The Dendrobium Mine is an underground coal mine situated in the Southern Coalfield of New South Wales (NSW) approximately 8 kilometres (km) west of Wollongong (Figure 1-1A). Illawarra Coal Holdings Pty Ltd (Illawarra Coal), a wholly owned subsidiary of South32 Limited (South32), is the owner and operator of the Dendrobium Mine.

In 2019, South32 submitted the *Dendrobium Mine – Plan for the Future: Coal for Steelmaking Environmental Impact Statement* (the EIS) for assessment under the NSW *Environmental Planning and Assessment Act, 1979* (EP&A Act).

This Submissions Report provides South32's responses to aspects raised in submissions. It has been prepared in consideration of the *Draft Guideline 4: Guidance for State Significant Projects - Preparing a Submissions Report June 2019* (DPIE, 2019).

Figure 6-3B – Variation in Inferred Height of Fracturing using the Tammetta Equation

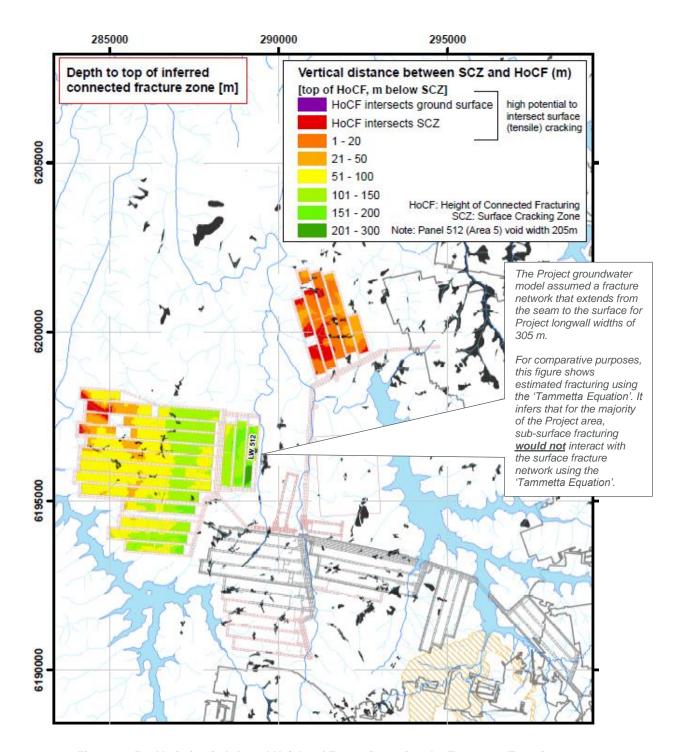
- If other recognised methodologies were used to estimate the height of sub-surface connective fracturing, in particular the 'Tammetta Equation', the majority of the Project underground mining area would not be modelled as having a fracture network that extends from the seam to the surface or extend to the surface fracture network (Appendix B of the EIS) (Figure 6-3B).

Figure 6-3D - Modelled vs Observed Groundwater Level Hydrographs - Bores S2313 and S1932

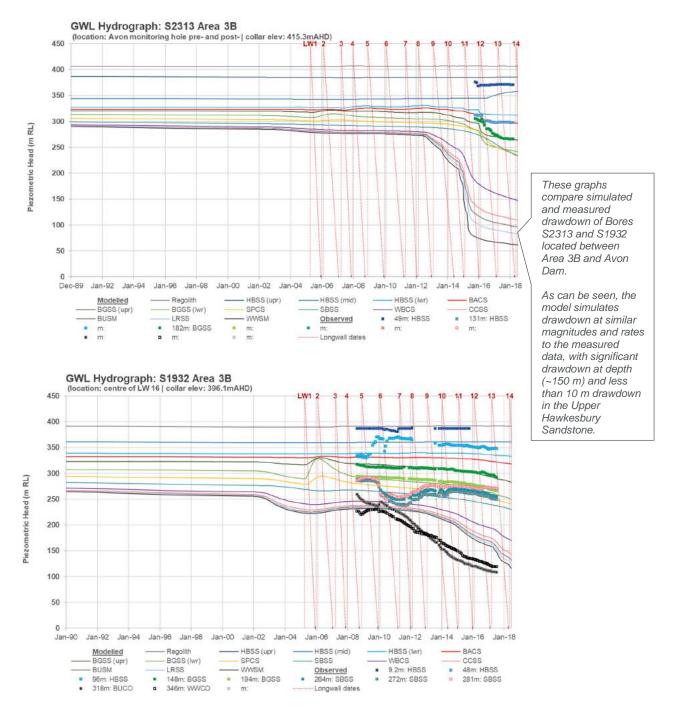
- The model simulates drawdown at a similar magnitude and rate near to and above longwalls (e.g. Figures 7-5 and 7-16 of the Groundwater Assessment [Appendix B of the EIS] and reproduced below in Figure 6-3D) when compared to piezometer data, e.g. with significant drawdown at depth (e.g. ~150 m drawdown in Wongawilli Seam at bore S1992) and less drawdown higher above the seam (e.g. S1992 exhibits 80 m drawdown in the Scarborough Sandstone, <40 m drawdown in Bulgo Sandstone and less than 10 m drawdown in the upper Hawkesbury Sandstone). Within the model, most of this drawdown is associated with simulated drainage of groundwater into the mine workings via the 'stacked drains' mechanism, whereas in reality more drawdown might be associated with lateral drainage away from the mine footprint.</p>

Figure 6-3E - Predicted vs Observed Mine Water Inflow at the Dendrobium Mine

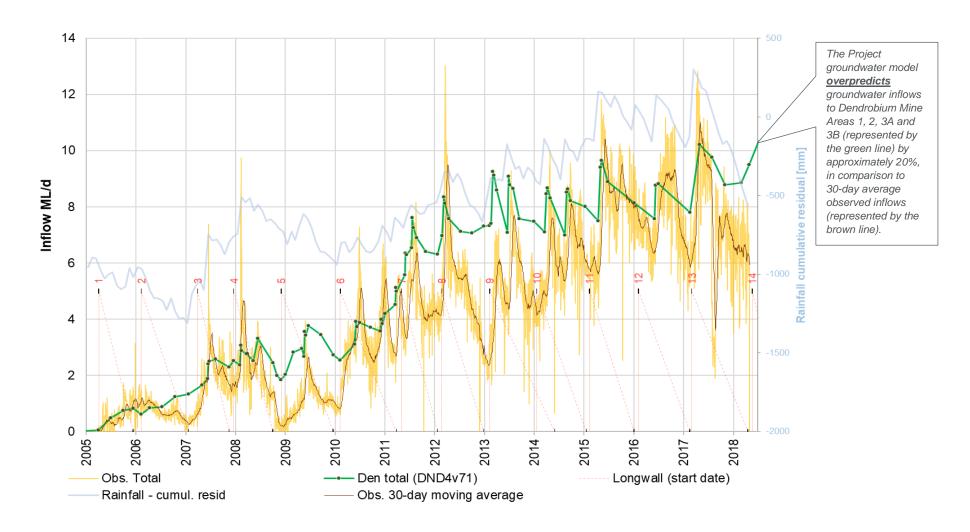
- The model has a tendency to overpredict total historic mine inflows to Areas 1-3B by approximately 20%, in comparison to the 30-day average observed inflows (Figure 6-3E).

Chart 6-3A - Measured Groundwater Level on Avon Dam Shoreline (After: HGEO [2018])

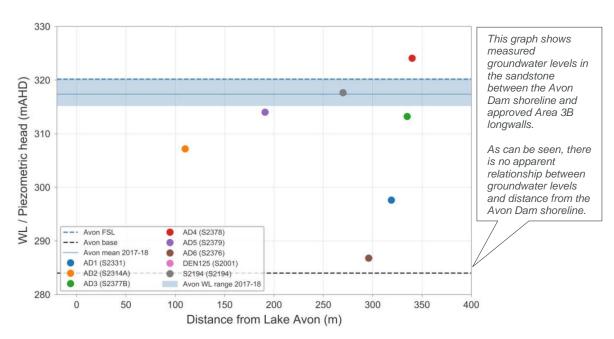
It is noted that groundwater levels in the section of sandstone between the Avon Dam shoreline and the longwalls vary, with no apparent relationship between groundwater levels (or depressurisation) and distance from the Avon Dam shoreline (Chart 6-3A).

Chart 6-3B - Measured Permeability of Sandstone on Avon Dam Shoreline

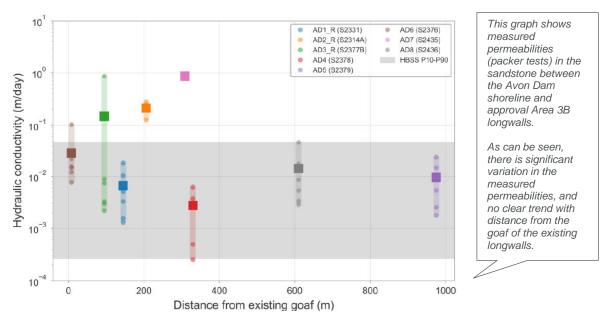
Similarly, horizontal hydraulic conductivity (measured using packer tests) varies significantly (i.e. orders of magnitude) with no clear trend with distance from the goaf (Chart 6-3B).

Figure 6-3J

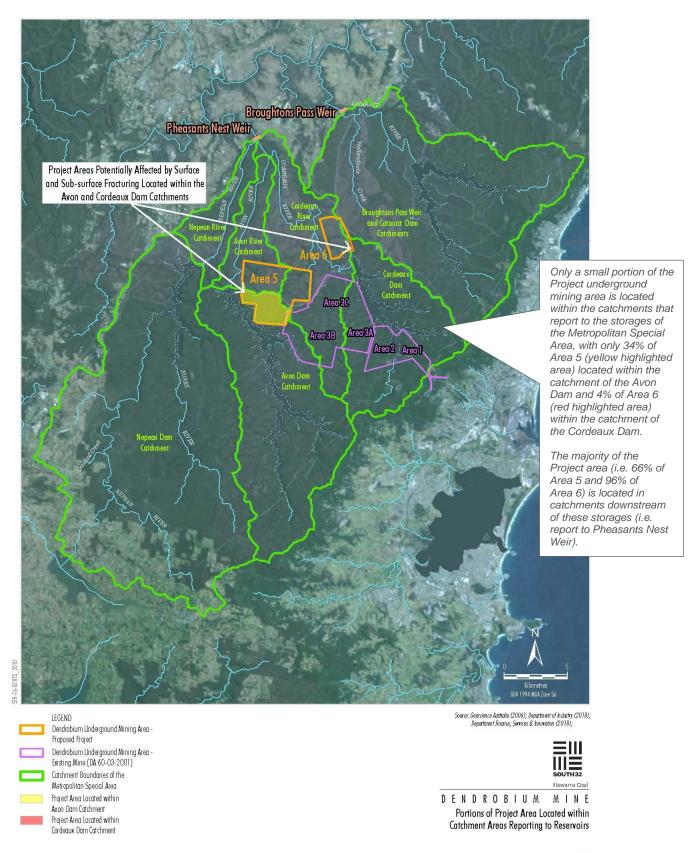
As shown in Table 6-3B and Figure 6-3J, only a small portion of the Project underground mining area is located within the catchments of the storages within the Metropolitan Special Area (i.e. the Avon and Cordeaux Dams) (Figure 6-3J). The majority of the Project underground mining area is located in the catchment downstream of the dam (Figure 6-3J).

The majority of predicted Mechanism 2 losses would not affect surface water supply to the Avon and Cordeaux Dams, as only 34% of Area 5 is located within the Avon Dam catchment area and 4% of Area 6 is located within the Cordeaux Dam catchment area (Figure 6-3J).

Figure 6-3K – Comparison of Maximum Predicted Surface Water Losses to Dam Operating Capacities and Security Yields

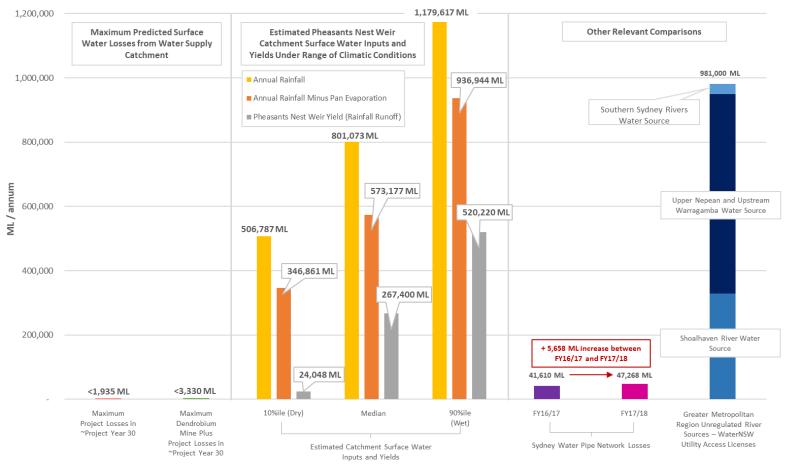
The maximum volume of surface water predicted to be diverted from the Avon and Cordeaux Dams (630 ML/annum and 79 ML/annum) is less than the 20% threshold values due to the Project and cumulatively (Figure 6-3K).

As shown on the graph, the maximum predicted surface water losses from the Avon and Cordeaux Dam catchments as a result of the Project are significantly less than the >20% security yields, and total operating capacities of these storages.

Figure 6-4A - Project Surface Water Licensing Requirements and Water Sharing Plan Allocations

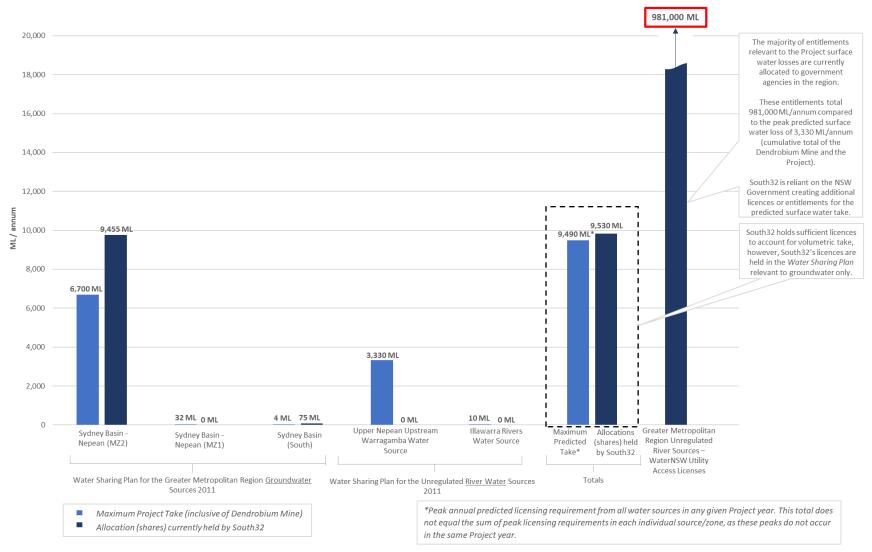
Although these licences account for peak surface water (and groundwater) take on a volumetric basis, they are not currently distributed to all of the required administrative water sources required for the Project (i.e. all are held within the water sharing plan relevant to groundwater sources, rather than surface water sources) (Figure 6-4A).

The estimated annual peak surface water losses due to the Project is equivalent to approximately 0.2% of the 981,000 ML/annum entitlement for unregulated river licences allocated to government authorities under the *Water Sharing Plan for the Greater Metropolitan Region Unregulated River Water Sources 2011* (Figure 6-4A).

Figure 6-4B

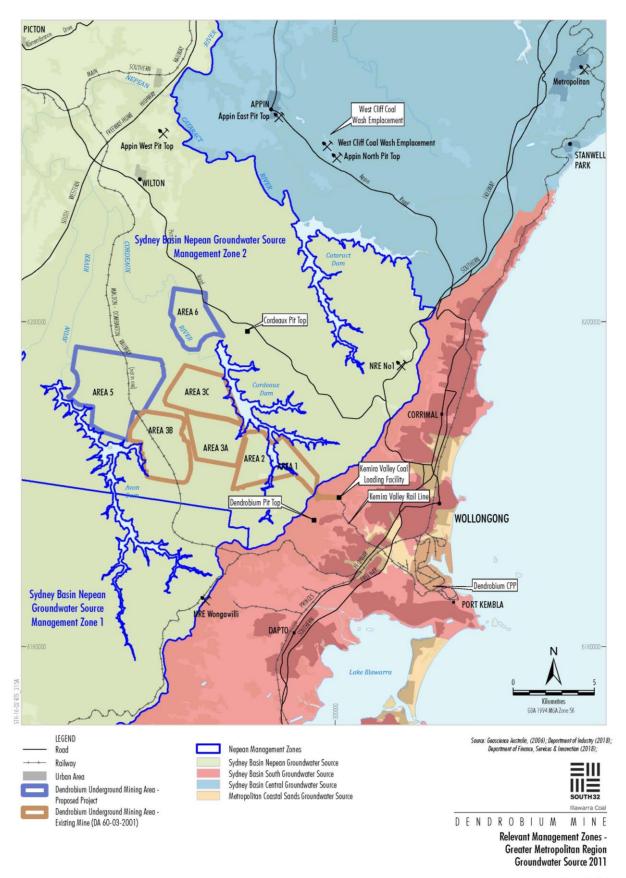
This is because when the Dendrobium Mine was approved in 2001, applicable water sharing plans under the NSW *Water Management Act*, 2000 were not developed, or in force. The water sharing plans applicable to the surface water losses for the Dendrobium Mine came into force in mid-2011 (Figures 6-4B and 6-4C).

Figure 6-9A – Swamp Den85 Groundwater Level and Soil Moisture Monitoring (March 2017 to February 2019)

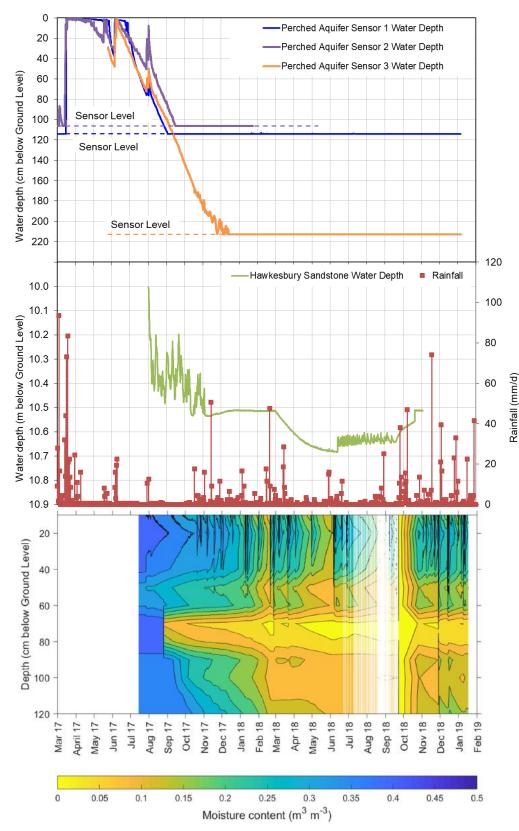
An example of baseline water level and soil moisture monitoring results (from 2017) within Upland Swamp Den85 in Area 5 is presented in Figure 6-9A. The swamp perched aquifer water level is at ground level when monitoring starts and steadily falls until below the sensor levels, which is reflected in the rapid decline of soil moisture that occurs in February 2018. Small increases in soil moisture can be observed following isolated rainfall events, however these increases are not sufficient to result in saturated conditions and therefore there is no rise in perched aquifer water level for the remainder of the monitoring period.

These graphs show (from top to bottom) water level monitoring, rainfall and soil moisture monitoring results in Swamp Den85 located above Area 5 (i.e. unaffected by mining to date).

Figure 6-12A: Investigation Boreholes and Mapping Boreholes that Identify a Geological Structure

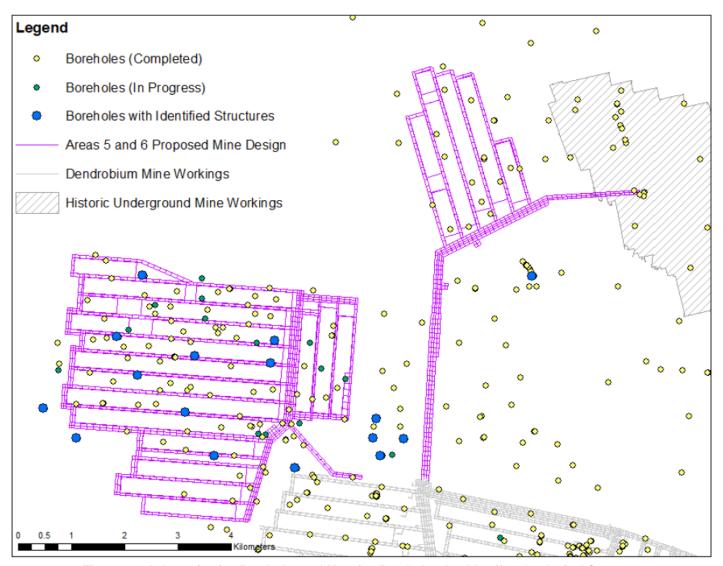
The Geological Structures Review for the Project was informed by analysis of previous borehole investigations conducted by South32, as well as additional borehole investigations conducted by PSM for the Project, to identify and infer underground geological structures within Area 5 and Area 6 of the Project (Figure 6-12A).

Figure 6-13B: Groundwater Model Extent and Location of Groundwater Bores

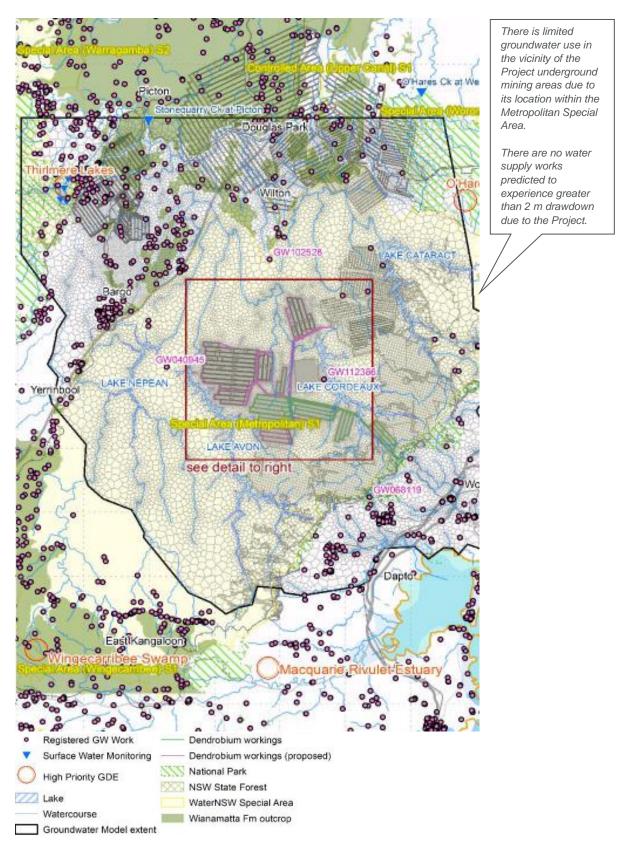
Groundwater bores located proximal to the Project (within a 40 by 40 km area of the Project underground mining areas) are predominantly located to the north-west of the Metropolitan Special Area around Tahmoor, Picton and Bargo, and to the east of the Metropolitan Special Area along the coastal plains (Figure 6-13B).
